MICROCHIP PIC18F2420/2520/4420/4520

PIC18F2420/2520/4420/4520 Rev. B4 Silicon Errata

FIGURE 1: SCK PULSE VARIATION USING TIMER2/2

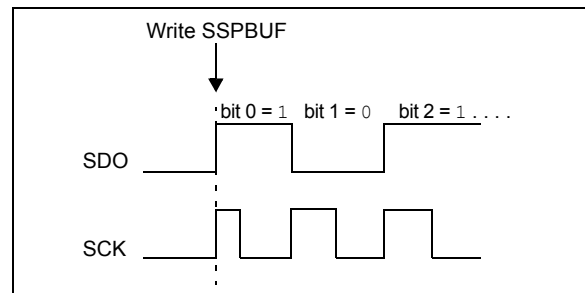
When the SPI is using Timer2/2 as the clock source, a shorter than expected SCK pulse may occur on the first bit of the transmitted/received data (Figure 1).

To avoid producing the short pulse, turn off Timer2 and clear the TMR2 register, load the SSPBUF with the data to transmit and then turn Timer2 back on. Refer to Example 1 for sample code.
